Access Compliance Report Public Rights-of-Way (Curb Ramps)

Main Street: DANZA_ST		Cross Street: VIVIDO_ST		Location:	E
ADA ID: RPRK211116134937	Ramp Type: Type 4 - Parallel	Initial Pass/Fail: Fail	Overall Compliance: No	Severity Score:	15

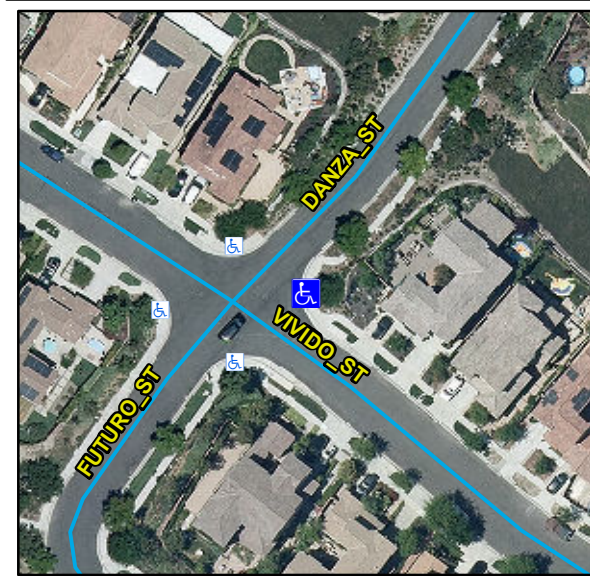
Compliance	Description	Data	Compliance	Description	Data
N/A	Ramp Length LT (in)	101	N/A	Ramp Length RT (in)	98
Yes	Ramp Width LT (in)	54	Yes	Ramp Width RT (in)	54
No	Ramp Run Slope LT (%)	8.9	Yes	Ramp Run Slope RT (%)	0.8
Yes	Ramp Cross Slope LT (%)	0	Yes	Ramp Cross Slope RT (%)	0.8
N/A	Landing Present	N/A	N/A	DWS Provided	N/A
N/A	Landing Length (in)	N/A	N/A	DWS Contrast	N/A
N/A	Landing Width (in)	N/A	N/A	DWS Length (in)	N/A
N/A	Landing Run Slope (%)	N/A	N/A	DWS Full Width	N/A
N/A	Landing Cross Slope (%)	N/A		DWS Offset Type	N/A
N/A	Landing Movement Obstructed?	N/A	N/A	DWS Offset Left (in)	N/A
	Landing Movement Type	N/A	N/A	DWS Offset Right (in)	N/A
N/A	Landing Shared	N/A			
N/A	Clear Space	Yes			
N/A	Clear Space To Crosswalk (in)	N/A			
N/A	Marked Crosswalk 1	No	N/A	Marked Crosswalk 2	No
	Crossing 1 Direction	NW		Crossing 2 Direction	SW
	Marked Crosswalk 1 Width (in)	N/A		Marked Crosswalk 2 Width (in)	N/A

Remove & Replace Curb Ramp With Two New Directional Ramps or Equivalent.

R304.3.2, STD 1115
